**Technical Service
Information Bulletin**

DIAGNOSTIC TROUBLE CODE P0446

'99 RX 300

REVISÉD
ENGINE
EG001-99

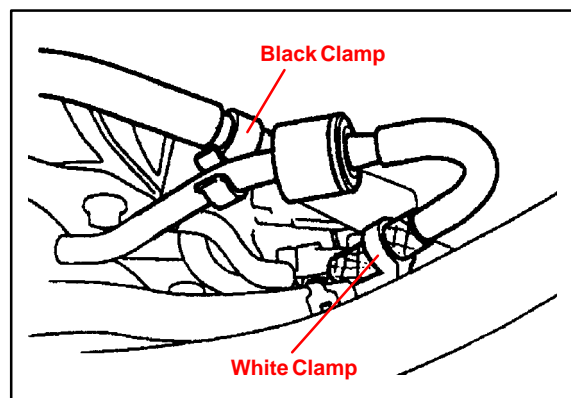
Introduction Under certain driving conditions, some 1999 Model Year RX 300s will exhibit a false M.I.L. "ON" DTC P0446. A Charcoal Canister Assembly has been developed to prevent this condition.

PREVIOUS PART NUMBER	CURRENT PART NUMBER	PART NAME
77740-48010	77740-48030	Charcoal Canister Assembly

1. Verify that the Purge System is operating as specified in the Repair Manual.
2. Raise vehicle on lift to gain access to the Charcoal Canister and remove the Charcoal Canister Assembly.
3. Install new Charcoal Canister Assembly.
4. Verify that all Vacuum/Purge Lines are attached securely.
5. Install Clamps on Purge Lines as shown in Illustration.
6. After lowering vehicle, verify that the Gas Cap is on securely.
